UNITED STATES PATENT AND TRADEMARK OFFICE

Office Action Summary	Application No. 10/645,965	Applicant(s) CLINE, L. STEVEN	
	Examiner Mr. Terry K. Cecil	Art Unit 1723

DETAILED ACTION

FIG. 1

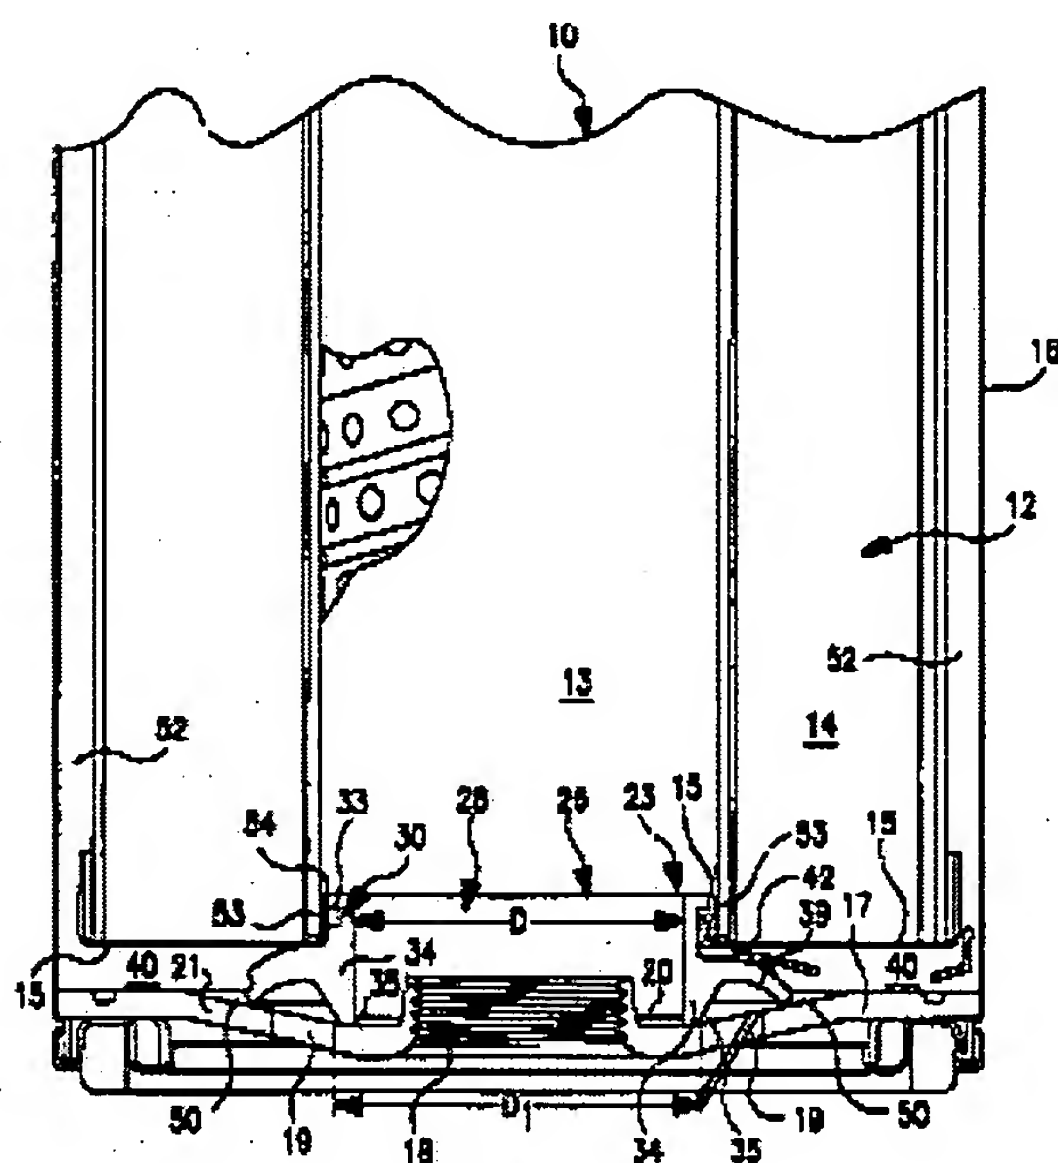
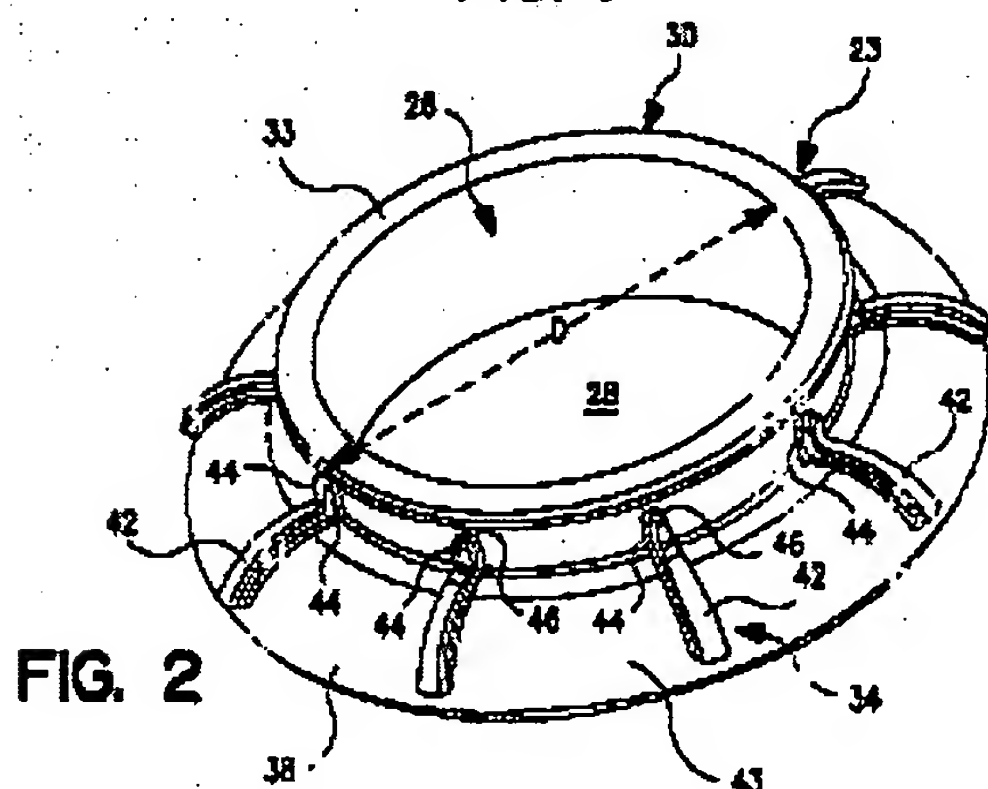
6. Claims 1-3, 5, and 8-14 are rejected under 35 U.S.C. 102(e) as being clearly anticipated by McKenzie (U.S. 6,793,808). McKenzie a fluid filter and valve assembly including a housing

having an end portion 17 including a threaded aperture and a central portion 53, 54 proximate thereto. An elastomeric valve assembly is positioned therebetween and includes an integral relief valve 30 and anti-drain back valve 34. See the drawings and the whole description thereof.

FIGURE 7

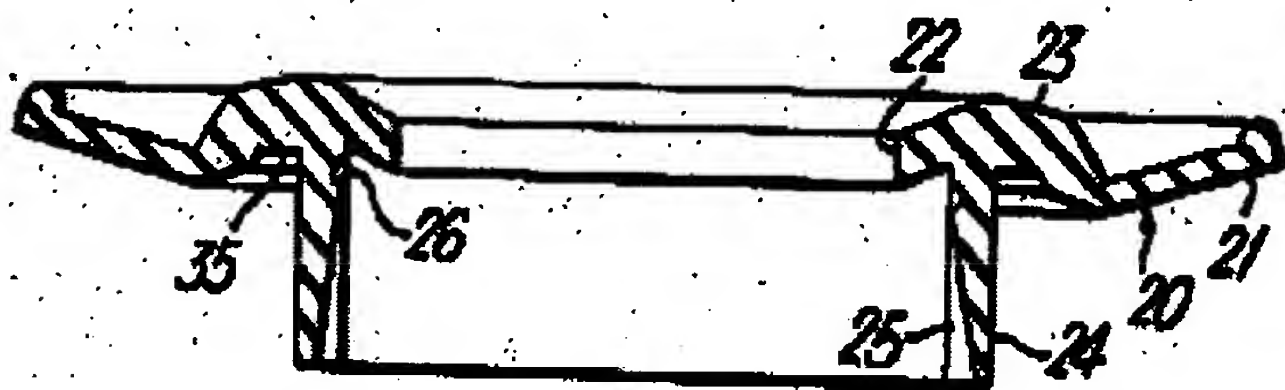
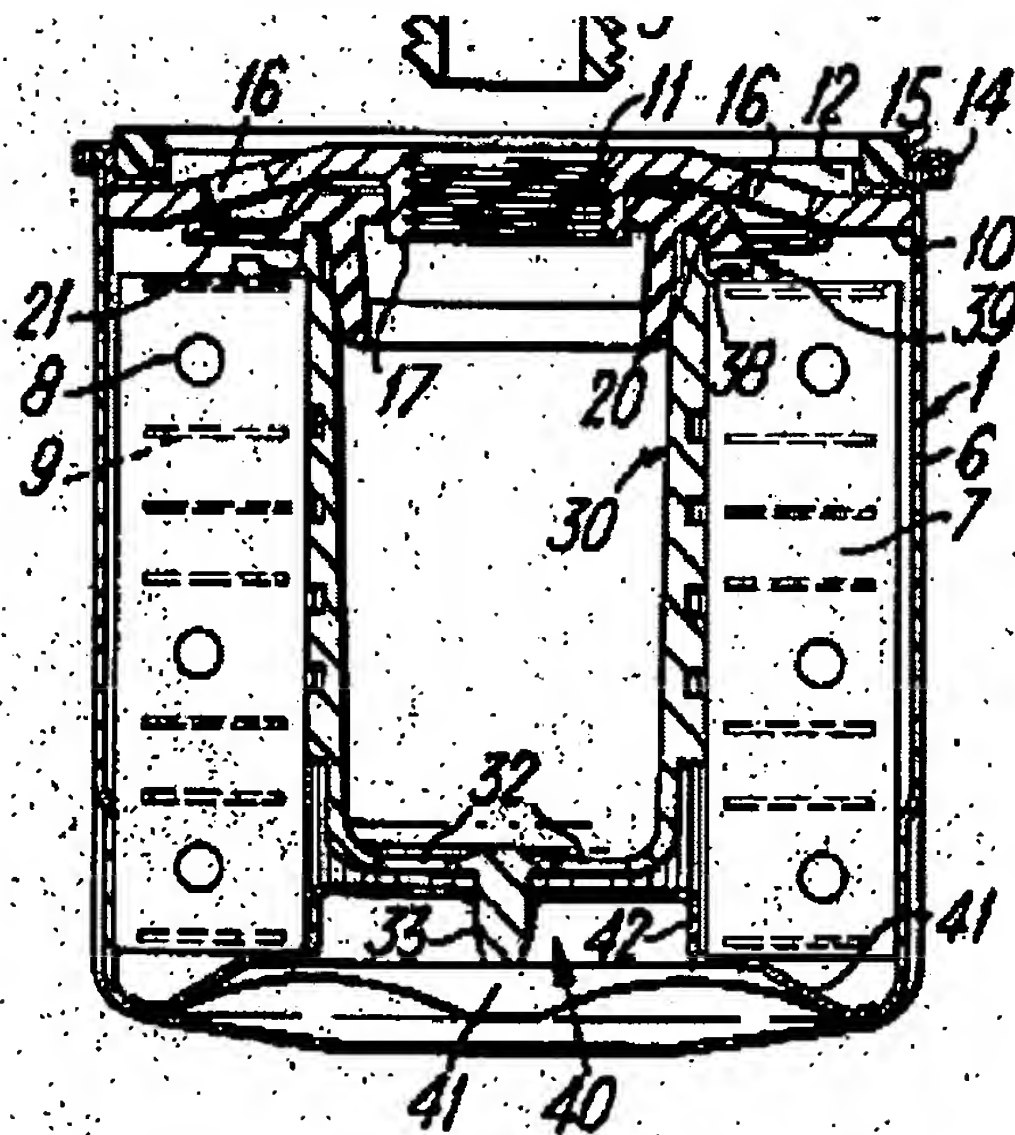
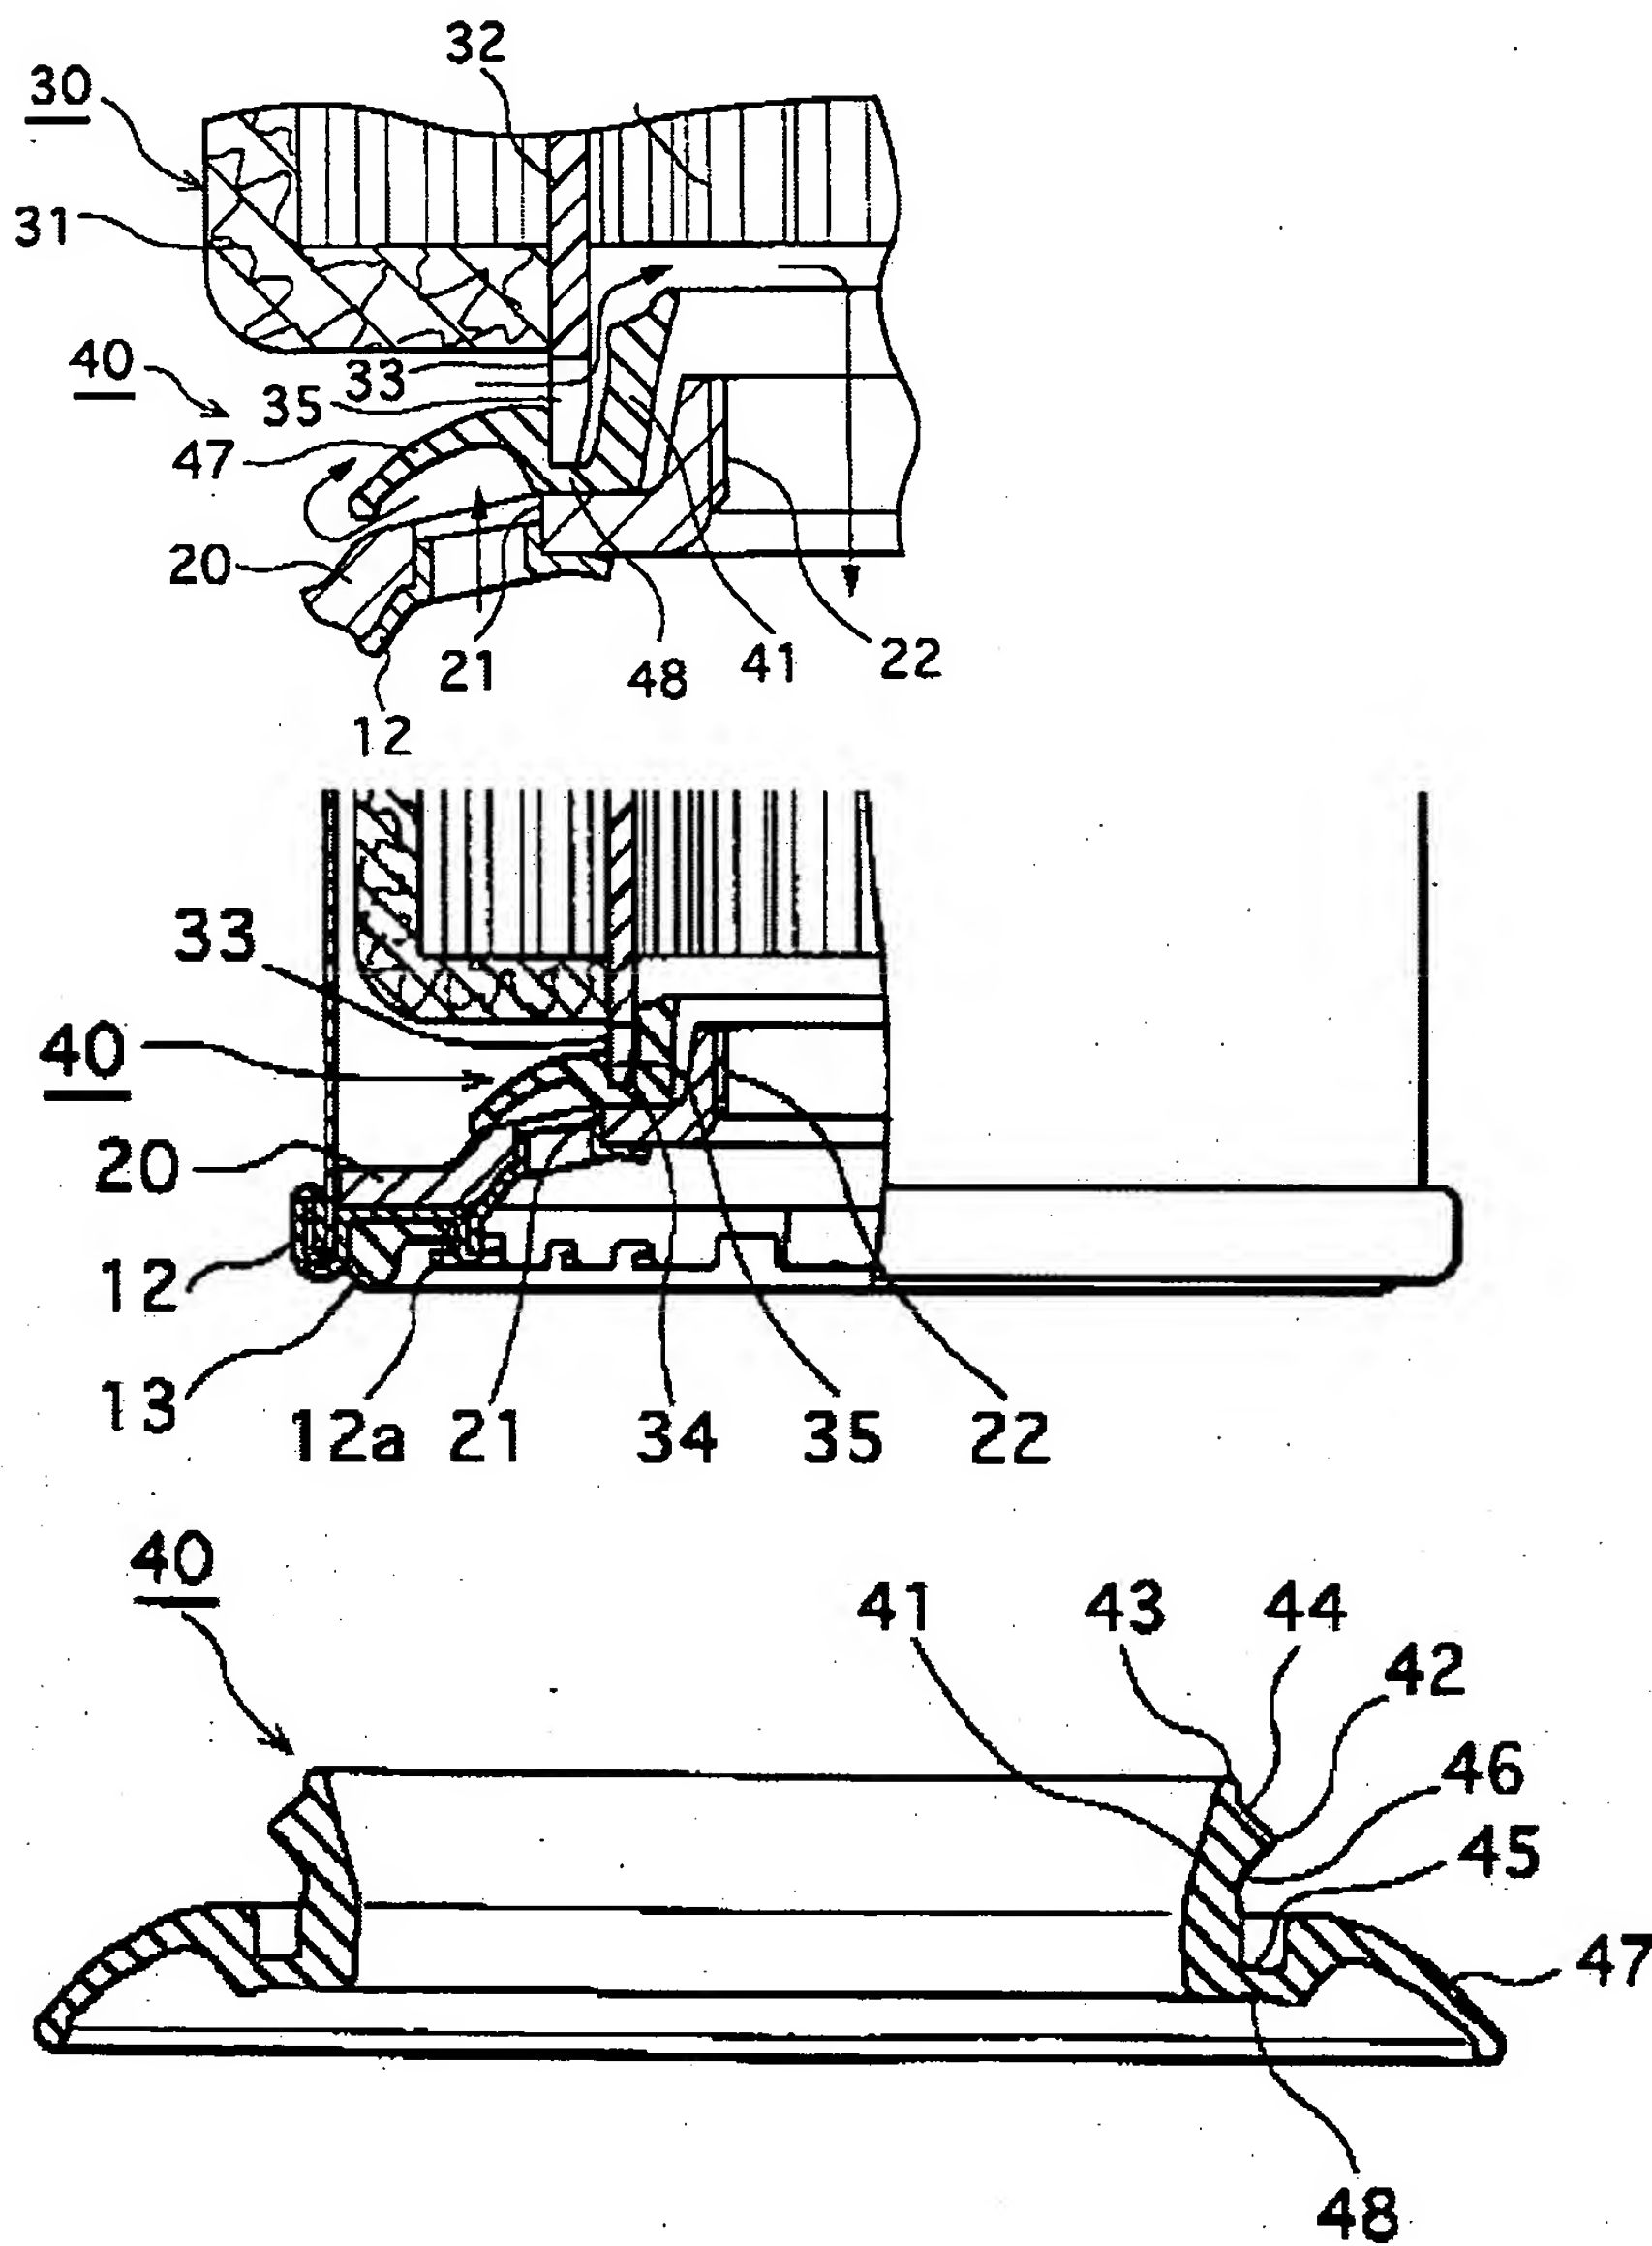
7. Claims 1-3 and 5-16 are rejected under 35 U.S.C. 102(b) as being clearly anticipated by Buckman (U.S. 3,567,023). Buckman teaches a fluid filter and valve assembly including a having an end portion 10 including a threaded aperture 11 and inlets 16 and a central portion 30 proximate thereto. An elastomeric valve assembly (figure 7) is positioned therebetween and includes an integral relief valve 24 and anti-drain back valve 20. The U-shaped recess 35 is also taught. See the drawings and the whole description thereof.
